METROPOLITAN GOVERNMENT OF NASHVILLE AND DAVIDSON COUNTY

Metropolitan Historic Zoning Commission
Sunnyside in Sevier Park
3000 Granny White Pike
Nashville, Tennessee 37204
Telephone: (615) 862-7970
Fax: (615) 862-7974

STAFF RECOMMENDATION 1531 Douglas Avenue October 19, 2016

Application: New construction—addition
District: Eastwood Neighborhood Conservation Zoning Overlay
Council District: 06
Map and Parcel Number: 07214023000
Applicant: Annie Lukach
Project Lead: Melissa Baldock, melissa.baldock@nashville.gov

Figures 1 and 2 show the left side roof which will be removed and reconstructed larger. The window that will become a door opening on the existing addition is marked with an arrow.

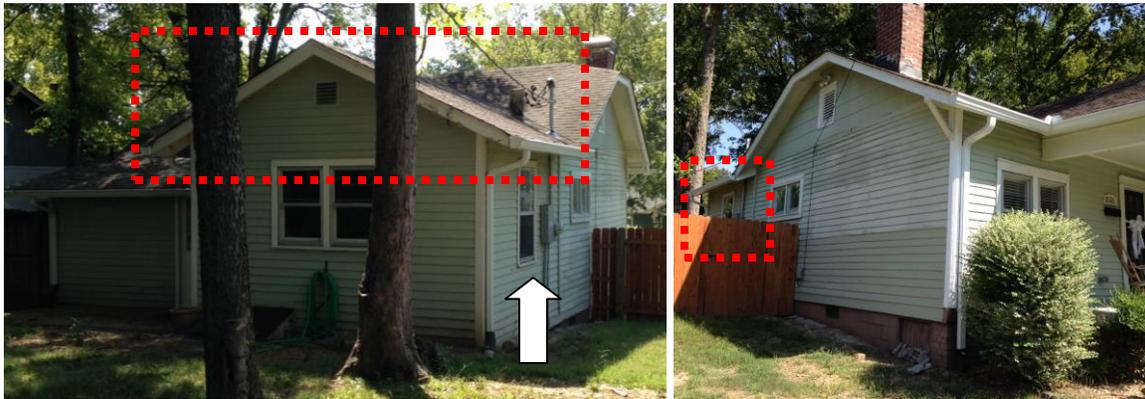
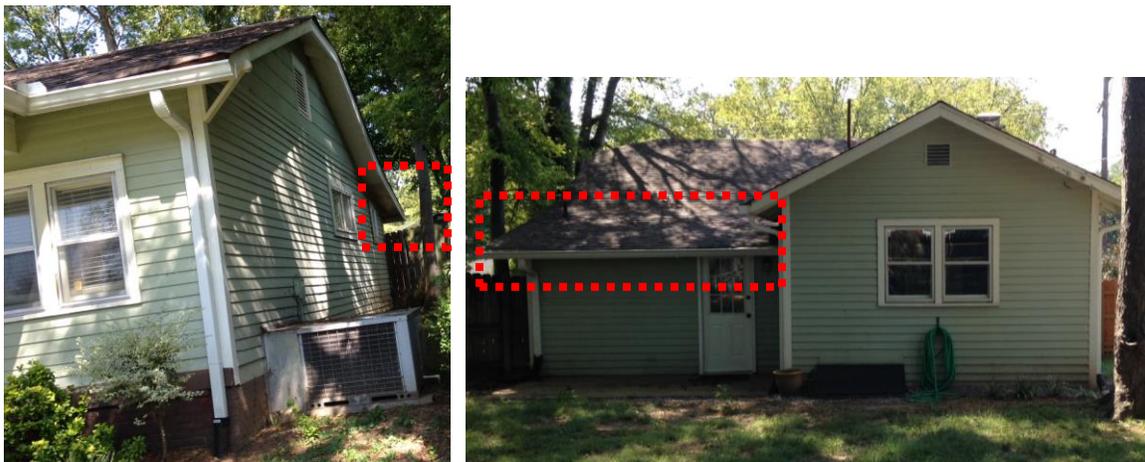
Partial Demolition: The proposed rear addition will alter the roof form of portions of the existing rear of the house. On the left side, the addition will build over an existing addition, retaining the walls and footprint, but altering the roof. This addition was constructed sometime in the mid to late twentieth century and does not contribute to the

historic character of the house (Figures 2 & 3). Staff therefore finds that the demolition of this roof is appropriate.

On the right side, the addition will alter the roof of an existing rear portion of the house that was likely once an enclosed porch (Figures 4 & 5). The existing roof is a low shed. It is not known when the porch was enclosed, but it was likely in the mid-twentieth century. Staff finds that the low shed roof is not a significant architectural feature, and that its removal for the construction of the new addition is appropriate.

The applicant intends to enlarge one window opening on the house to make it a door opening. This existing window opening is located on the house's existing addition. The window opening is not part of the historic house, and therefore staff finds its alteration to be appropriate.

Figures 3 & Show the right side shed roof, which was likely part of an enclosed porch. This roof will be removed and enlarged with the new addition.

Rear Elevation

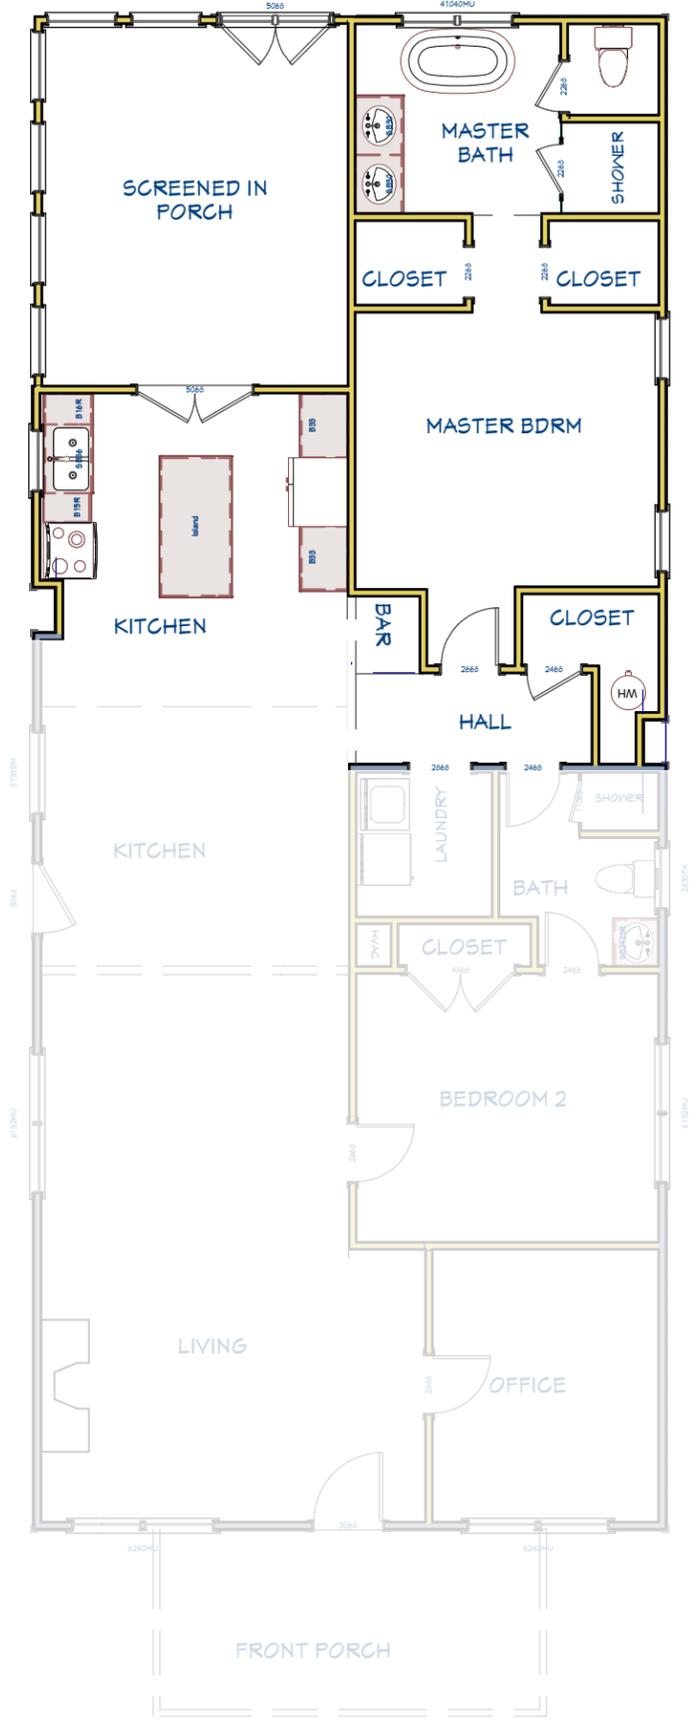
The windows on the proposed addition are all generally twice as tall as they are wide, thereby meeting the historic proportions of openings. There are no large expanses of wall space without a window or door opening. Staff recommends that the rear paired window opening have a four to six inch (4” – 6”) window opening in between the two windows. With this condition, staff finds the addition’s proportion and rhythm of openings to meet Sections II.B.1.g. and II.B.2. of the design guidelines.

Exterior Elevation Left

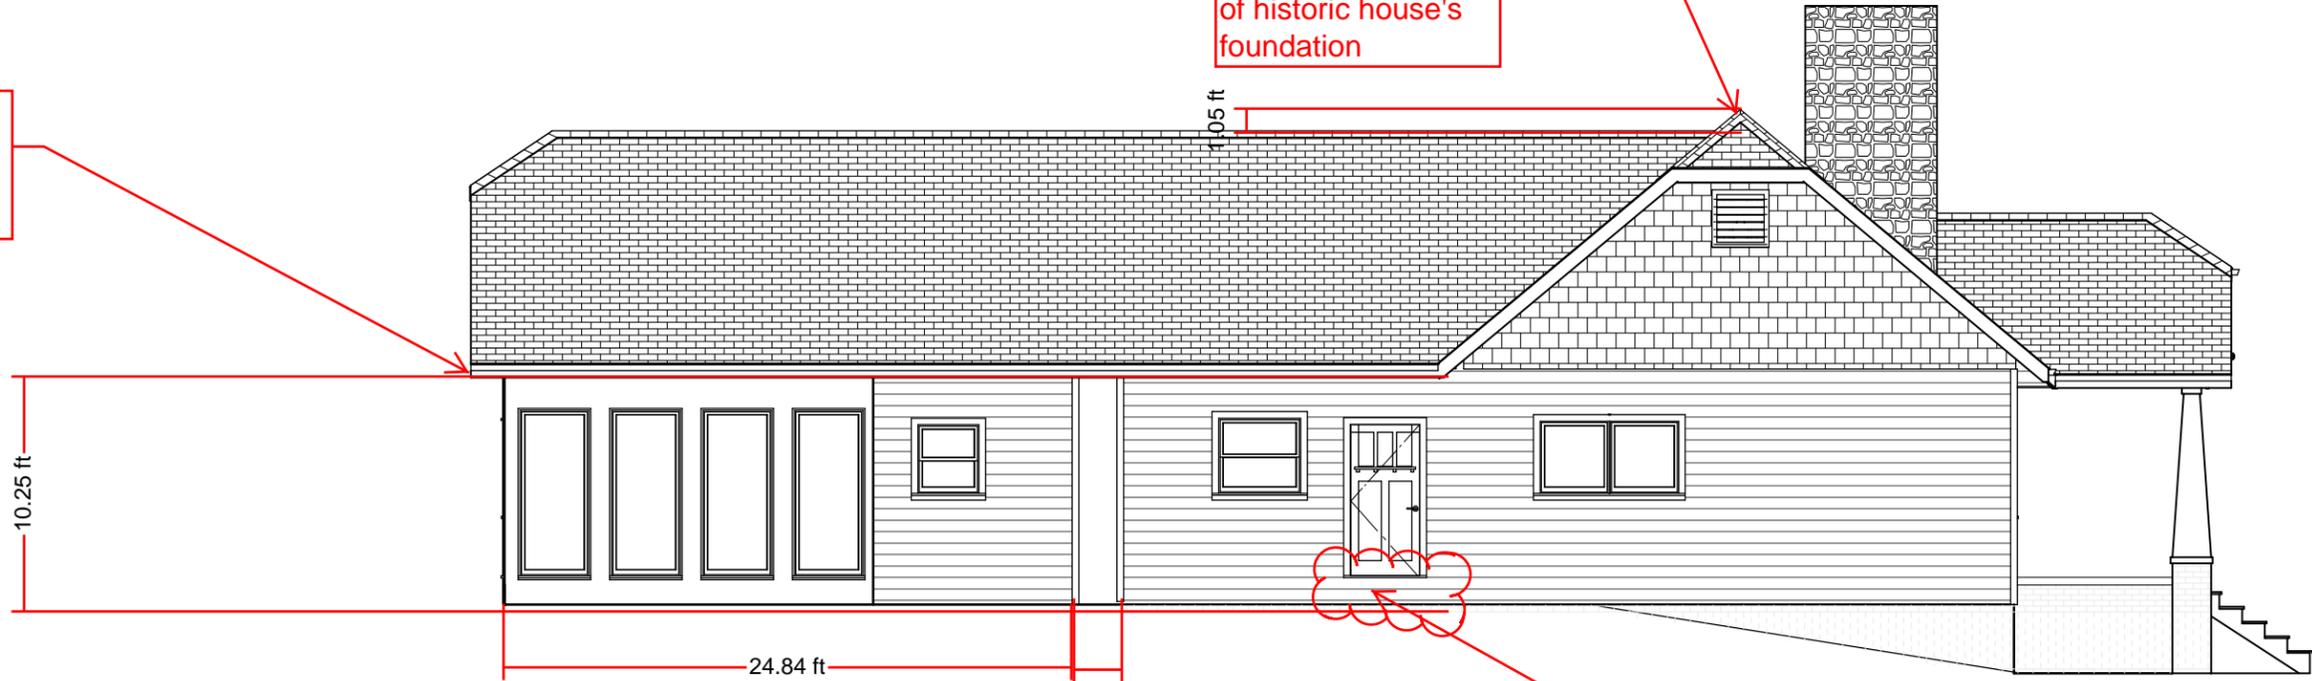
Eave height of addition should match eave height of house

Revised drawing should show design of steps and railing
